UNIVERSITY OF KENTUCKY Purchasing Division

CCK-2602-22

ADDENDUM # 1

ADDENDUM #1 – BID PACKAGE #2

E5.0

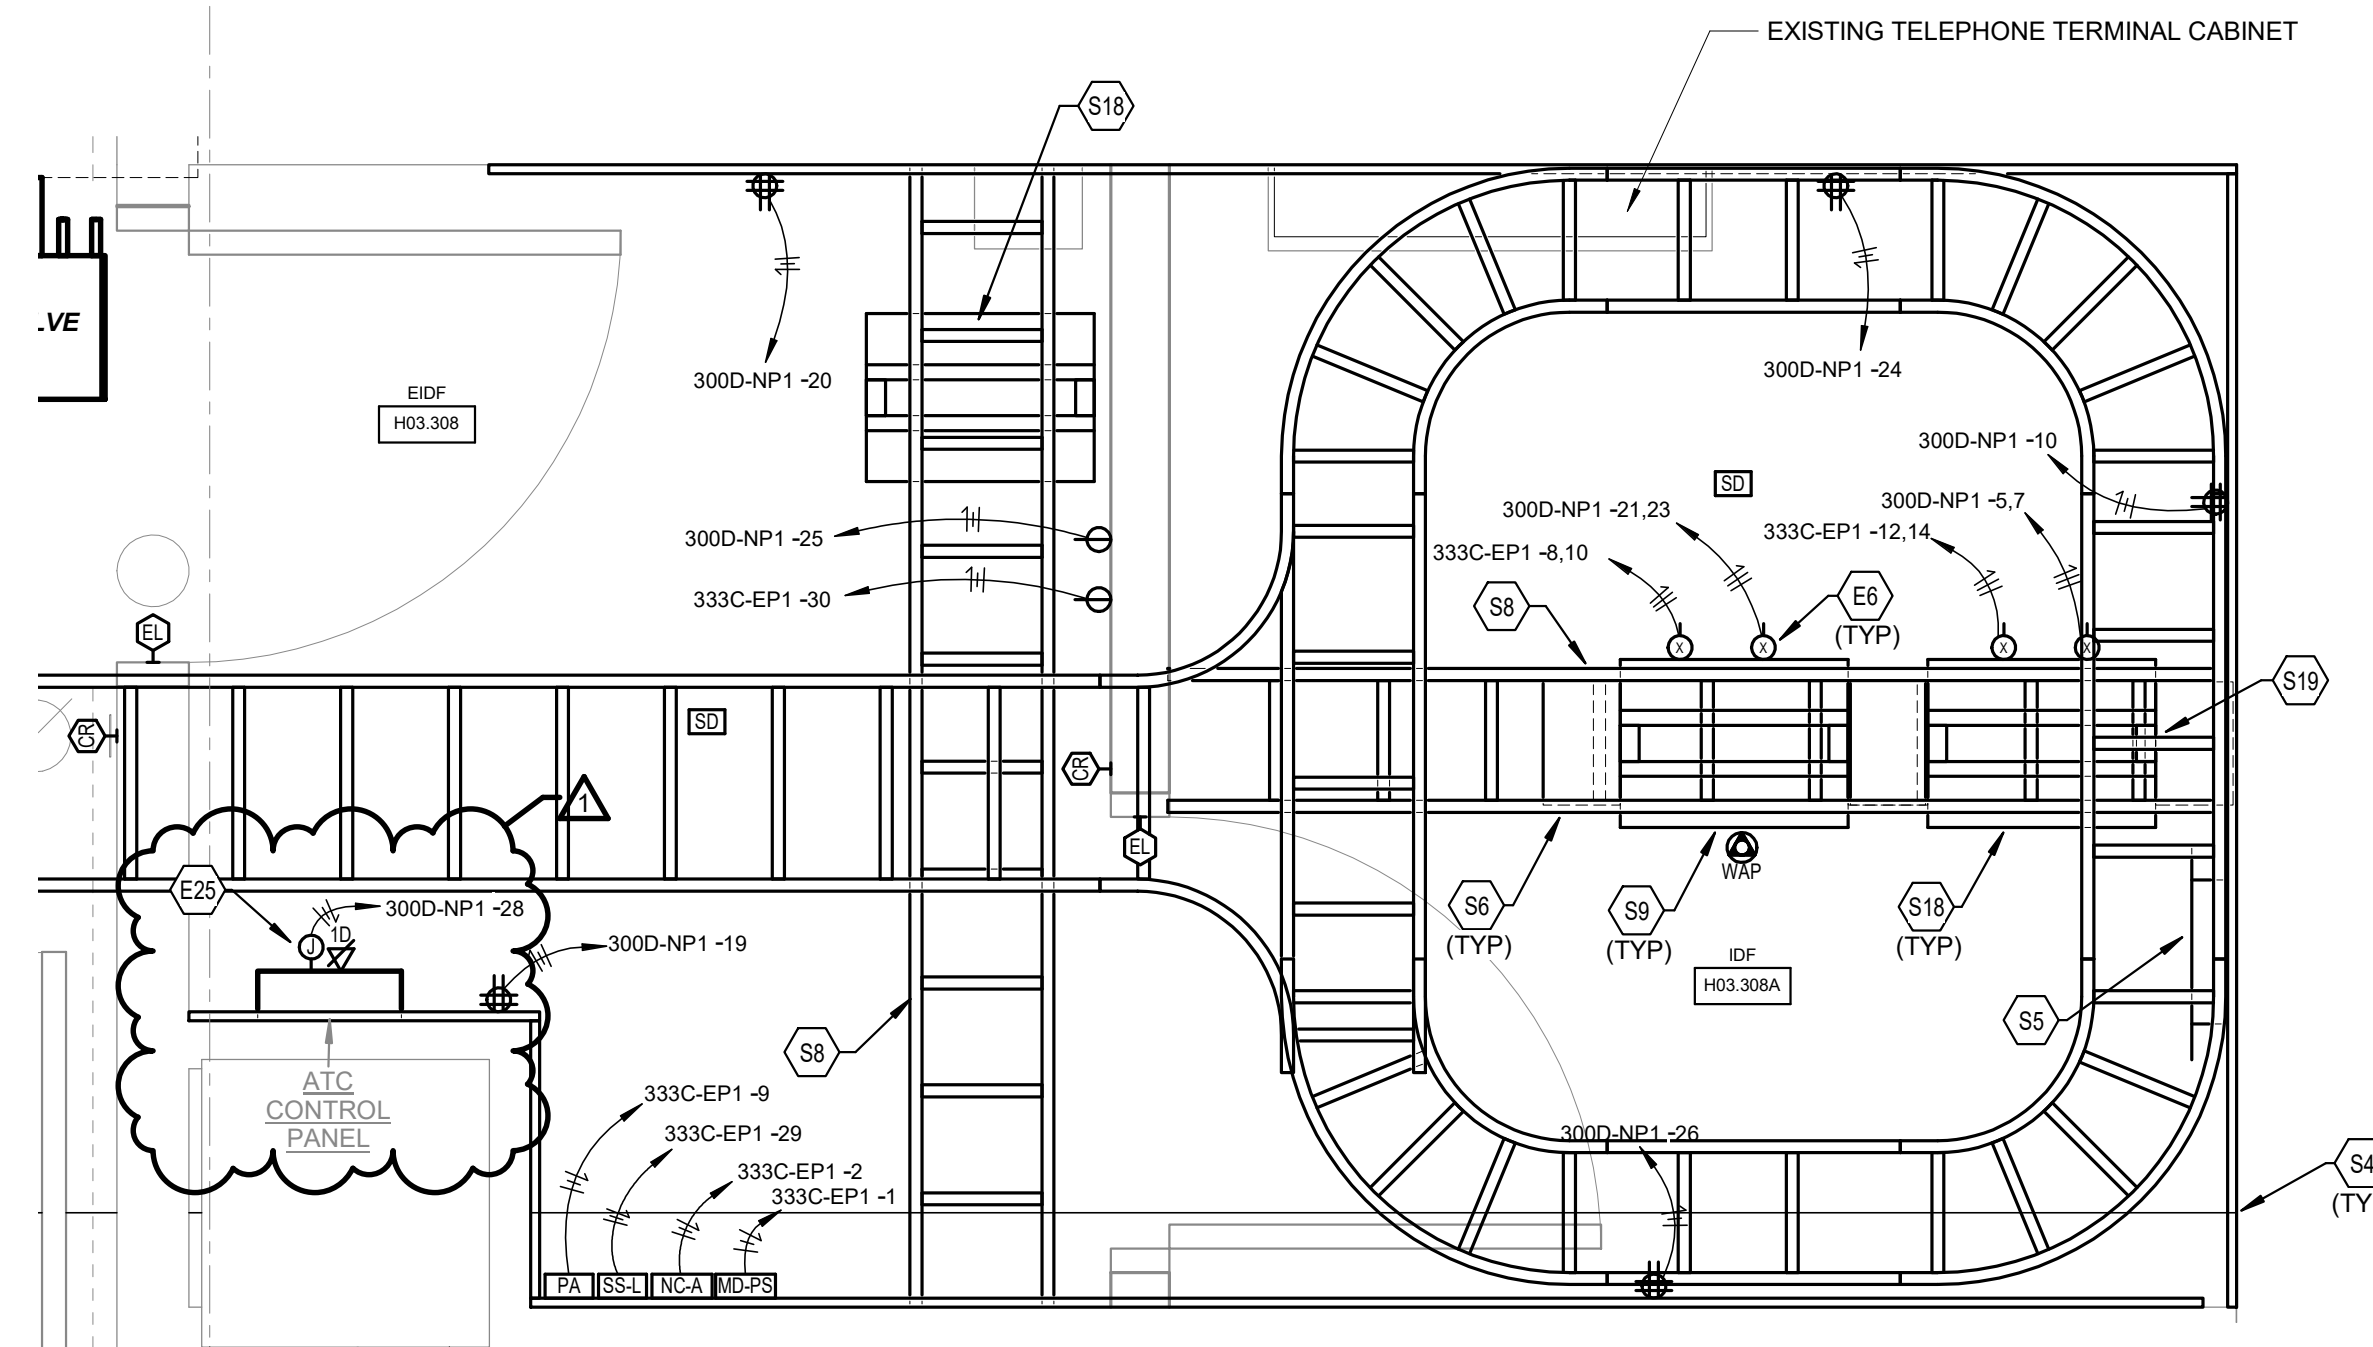
3.17 Reference: Sheet-E5.0

1 PATIENT ROOM LIGHTING CONTROL - ALTERNATE 1
SCALE: NONE

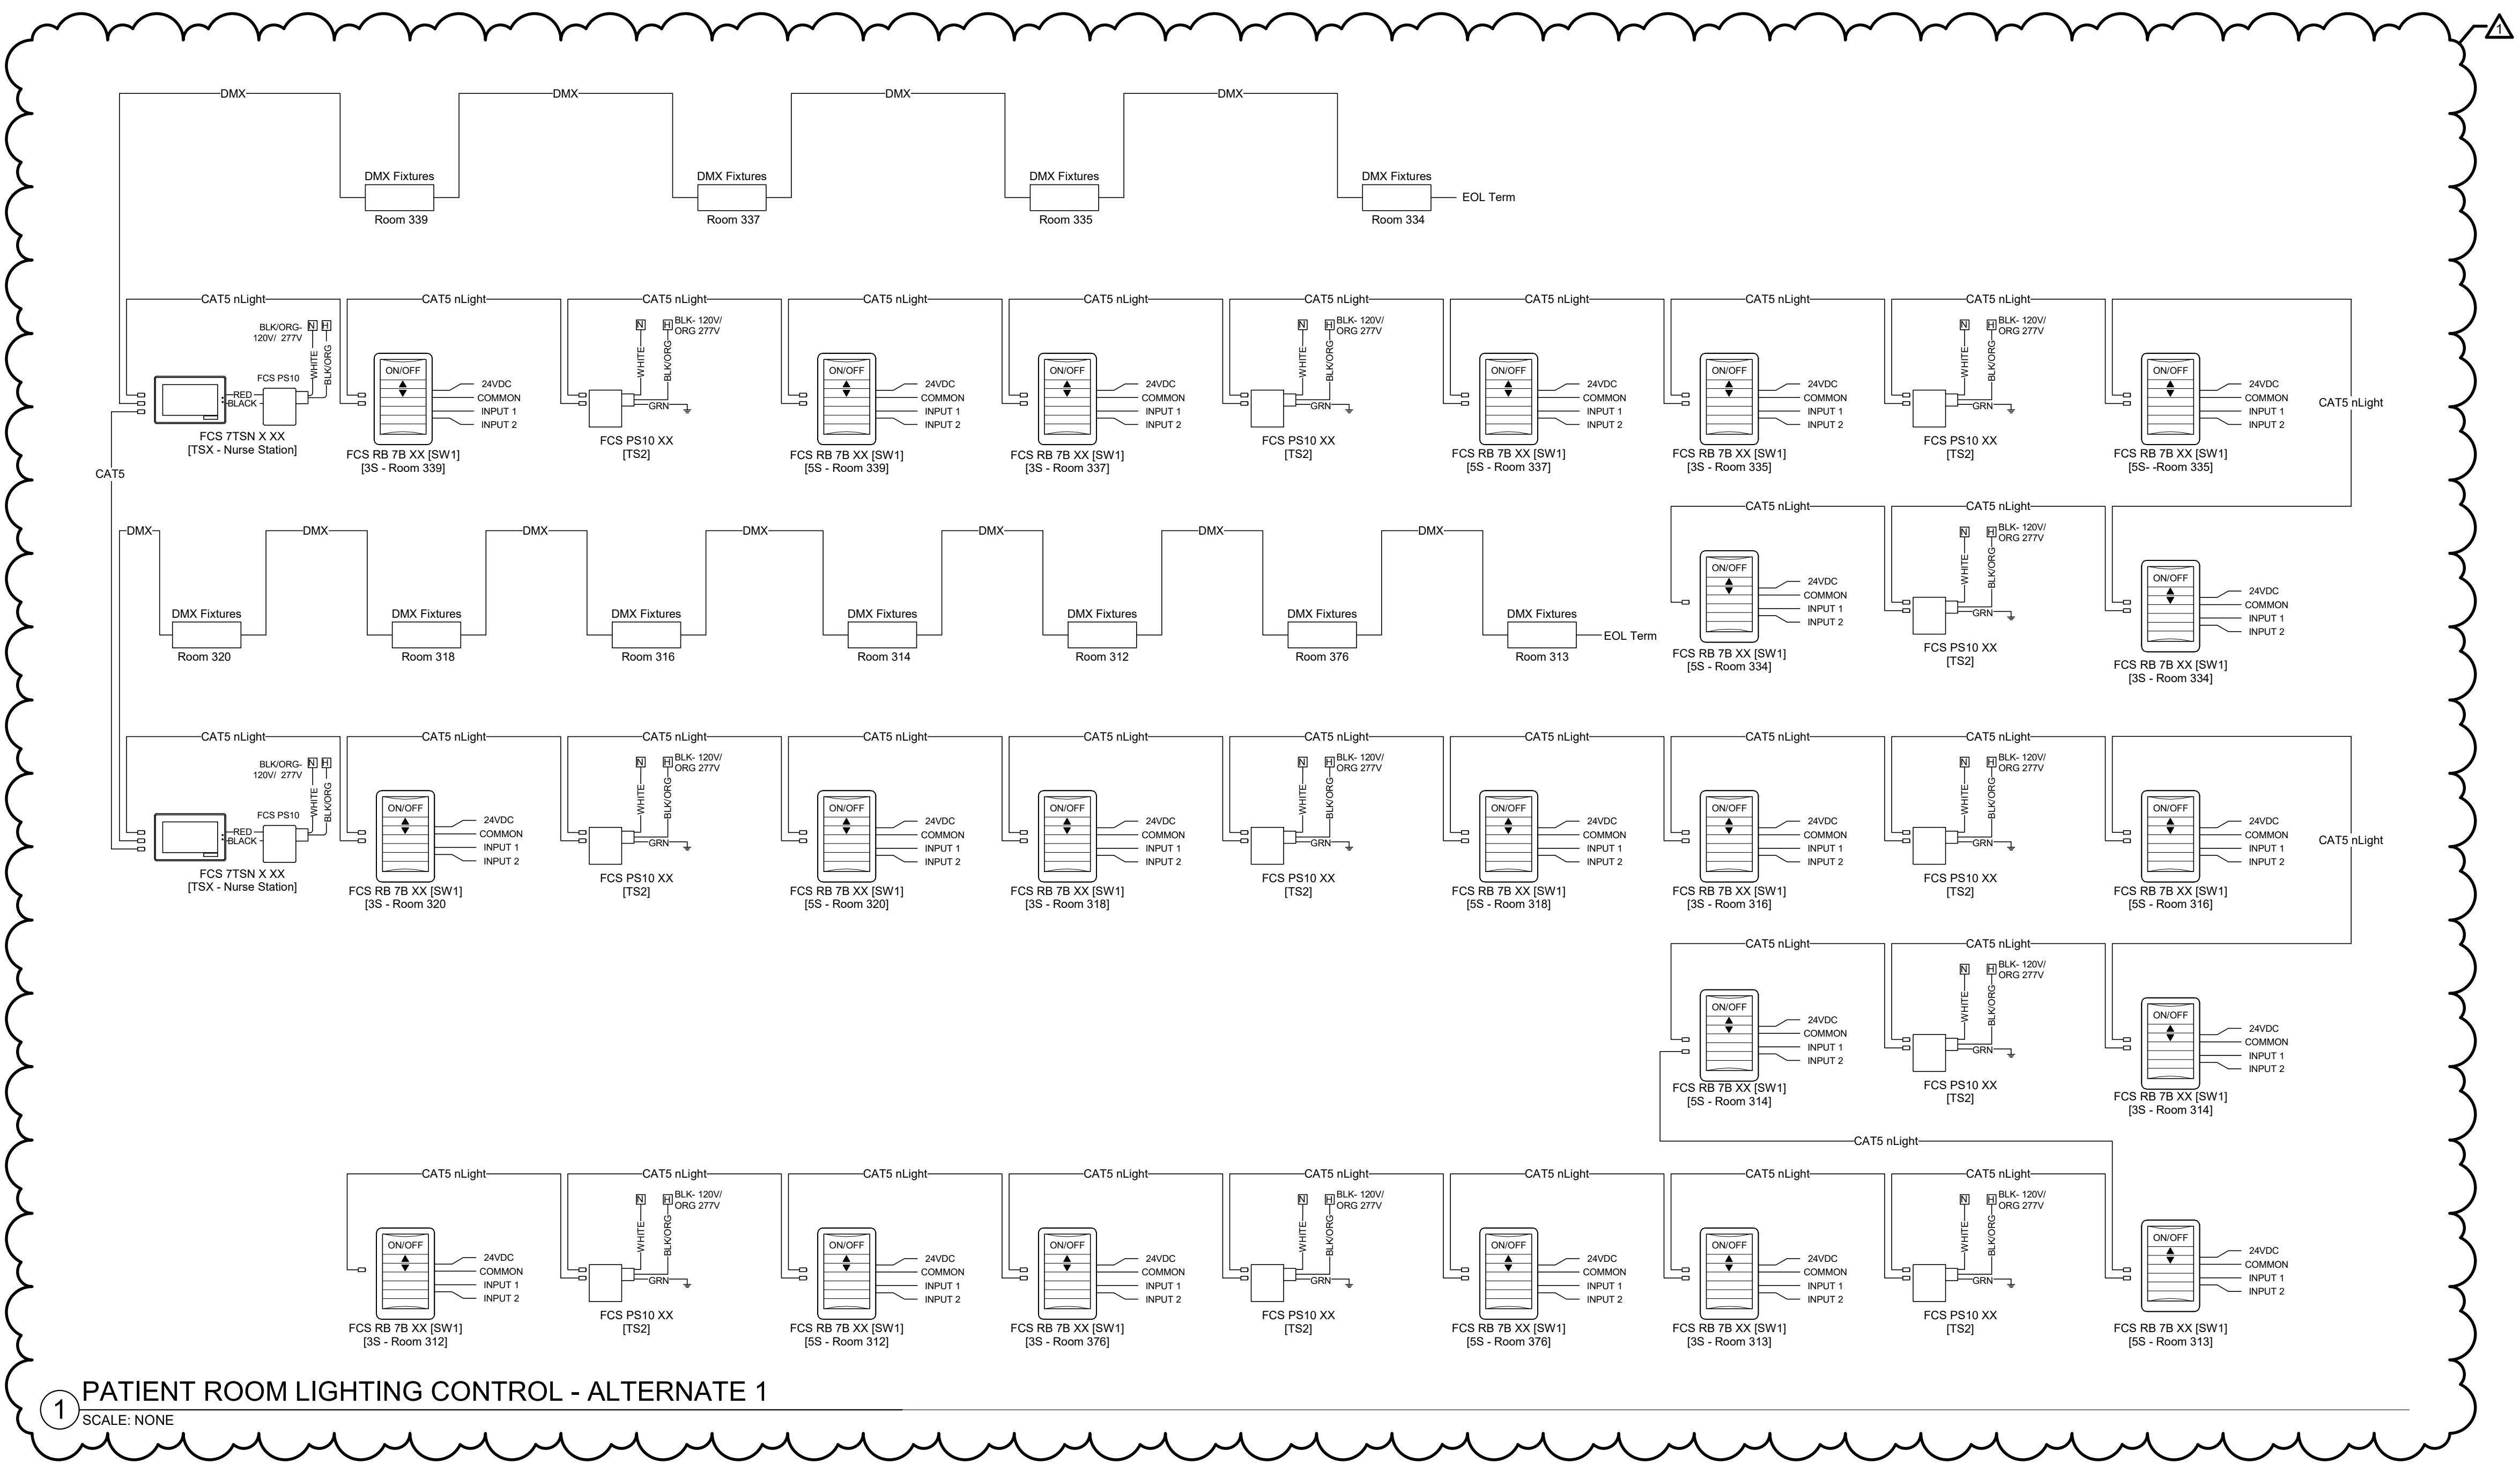
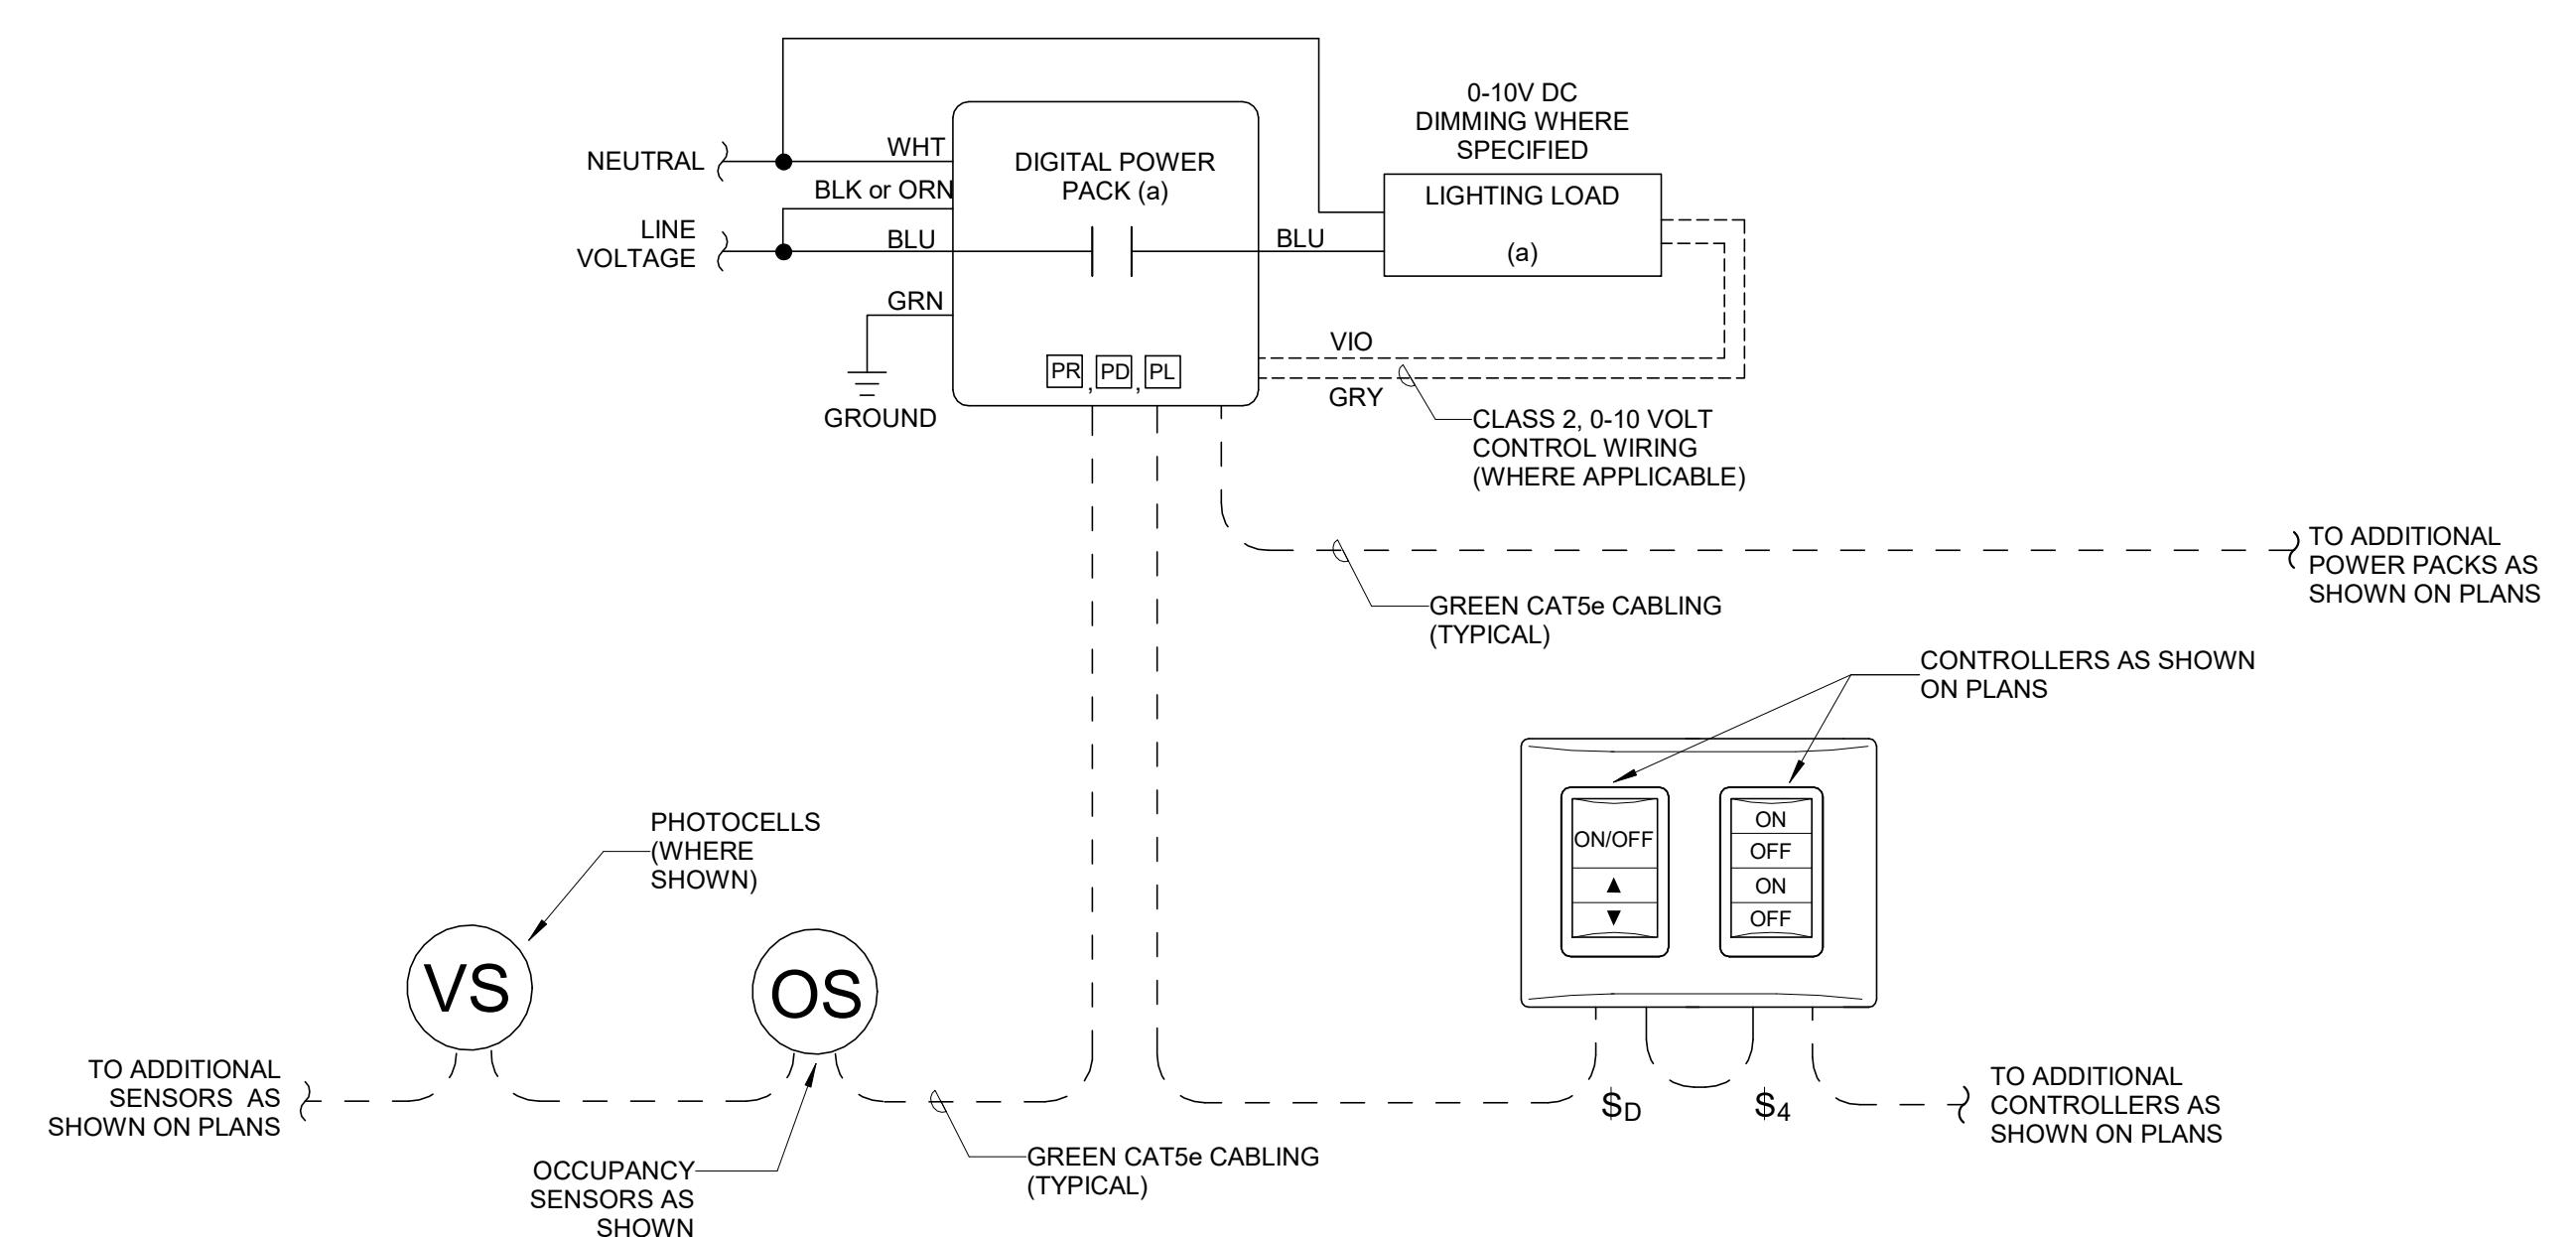
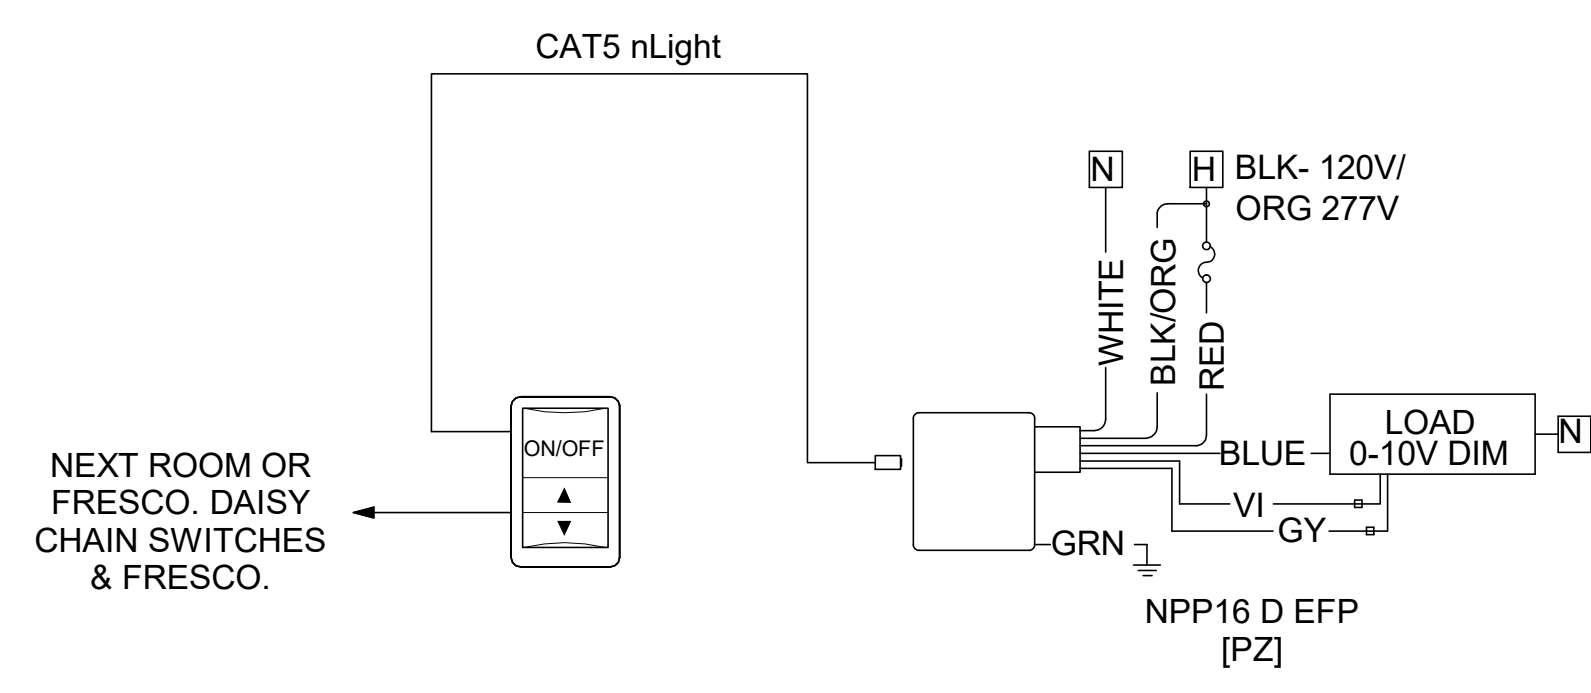
3.20 Reference: Sheet-E7.3
